Product Change Notification / NTDO-07MKOL484

Memolog ML062021000I Final Notice: Implement Serial number label changes for selected Microsemi DCS (Data Center Solutions) products.

Memolog ML062021000I
Pre and Post Change Summary
PCN: NTDO-07MKOL484

PCA-00344-XX Serial Number Label

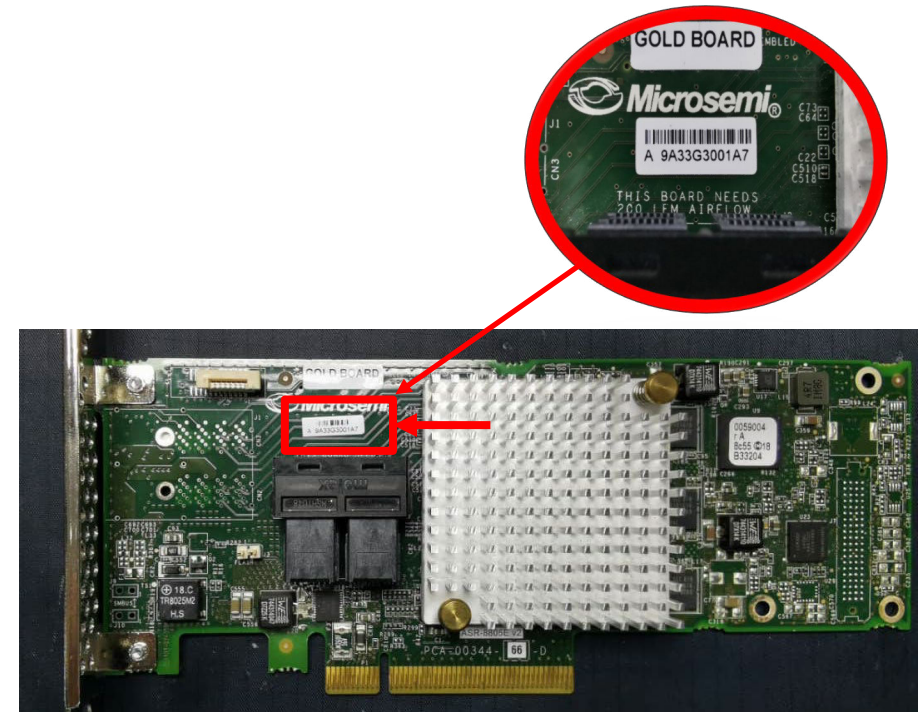
Old Serial Number Location

Smaller size and different location

PCA-00351-XX Serial Number Label

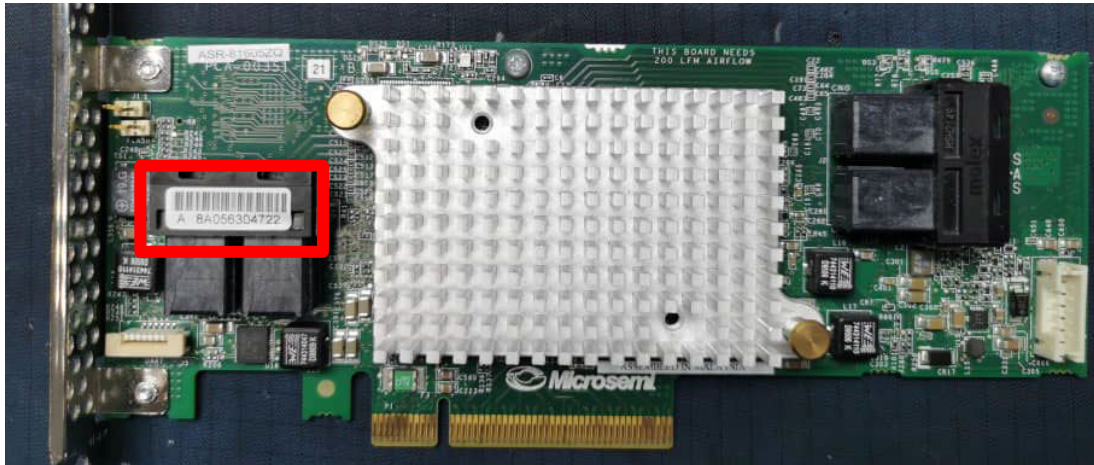
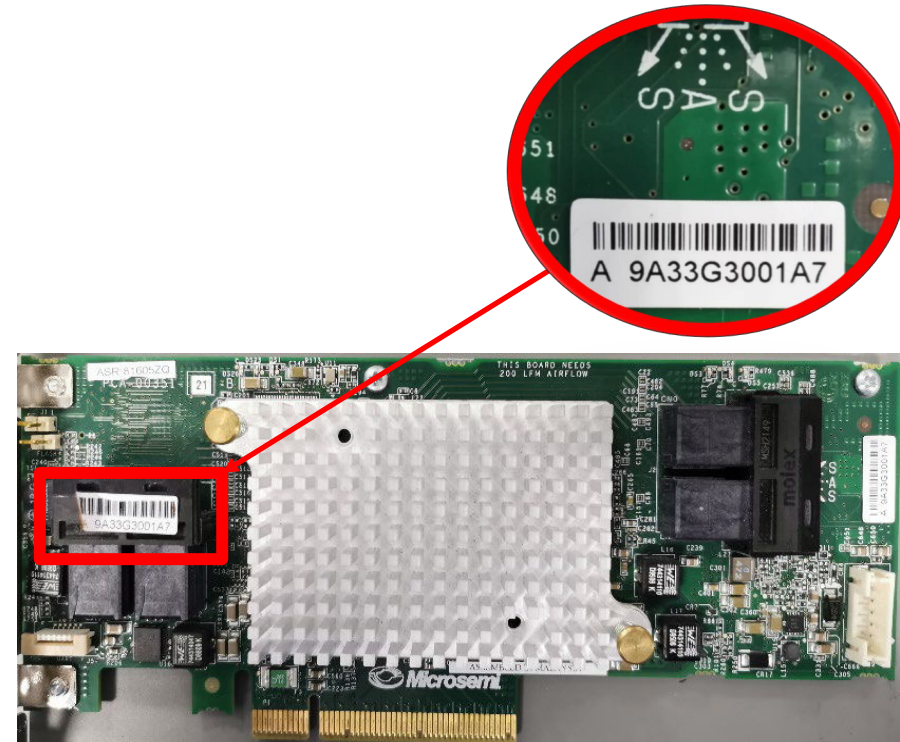
Old Serial Number Location

Smaller size and different location

PCA-00363-XX Serial Number Label

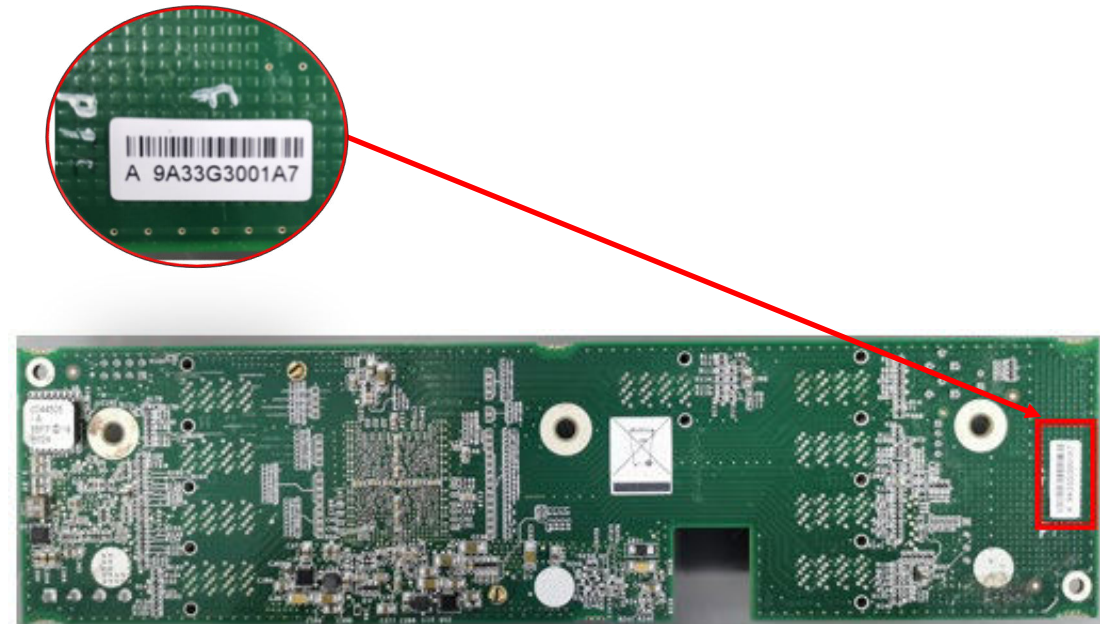
Old Serial Number Location

Smaller size and different location

PCA-00388-XX Serial Number Label

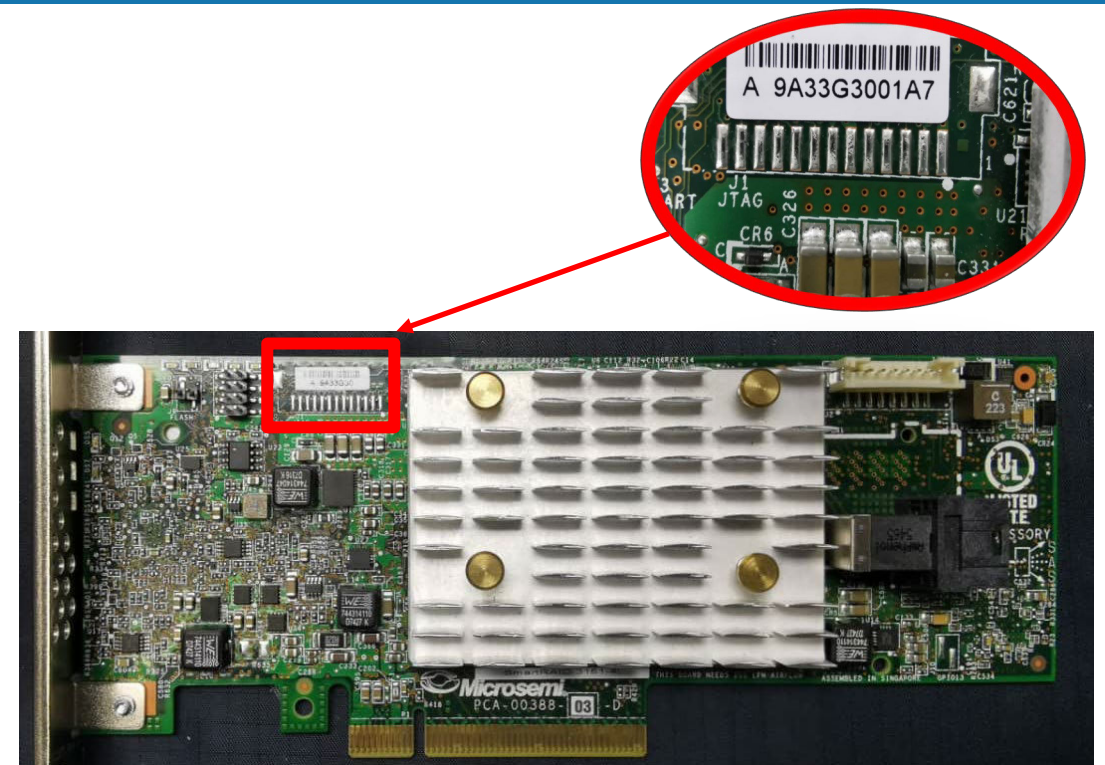
Old Serial Number Location

Smaller size and different location

PCA-00393-XX Serial Number Label

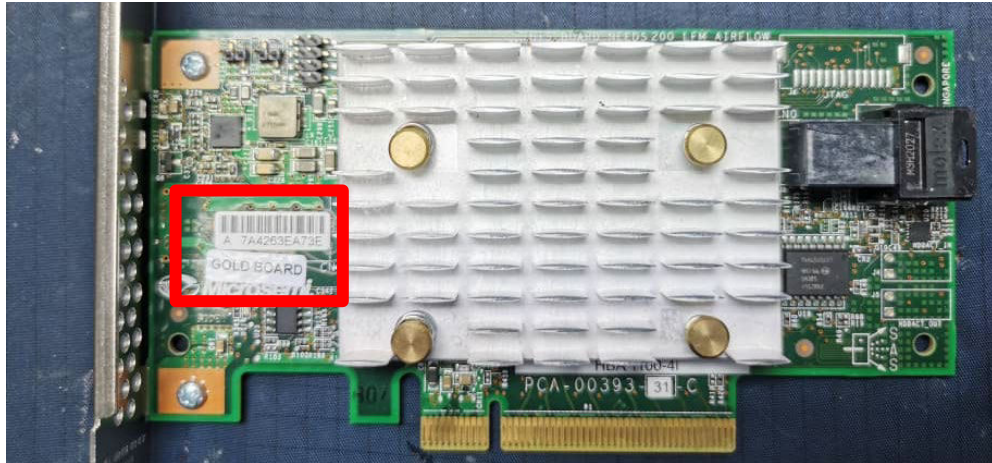
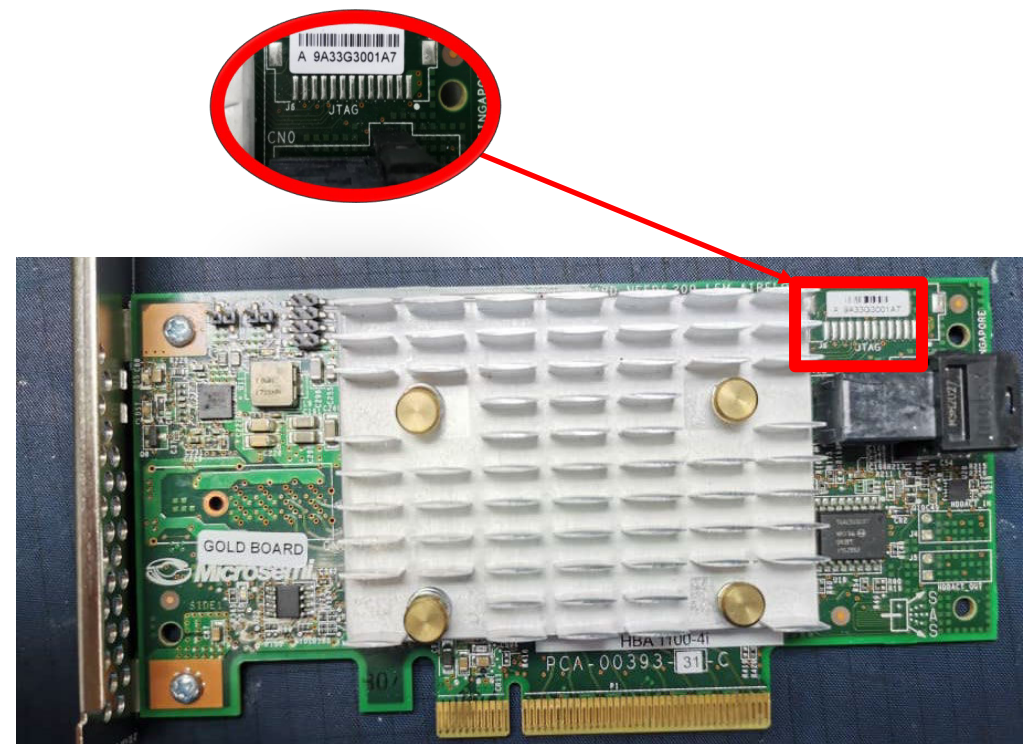
Old Serial Number Location

Smaller size and different location

PCA-00399-XX Serial Number Label

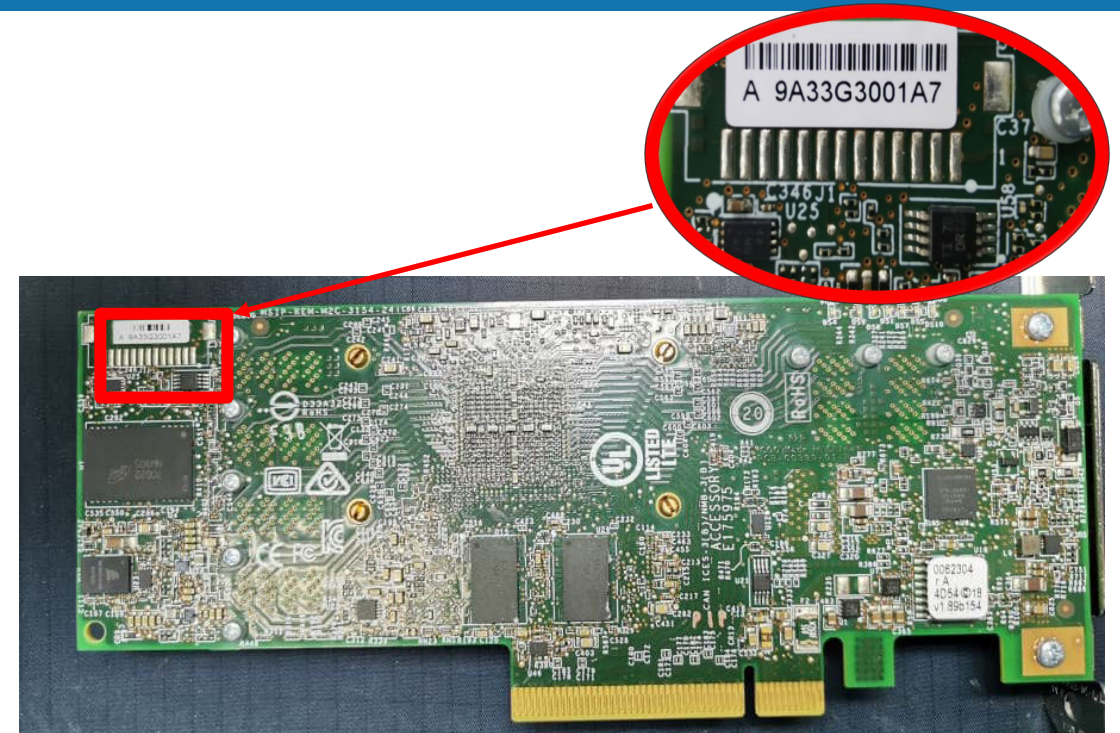
Old Serial Number Location

Smaller size and different location
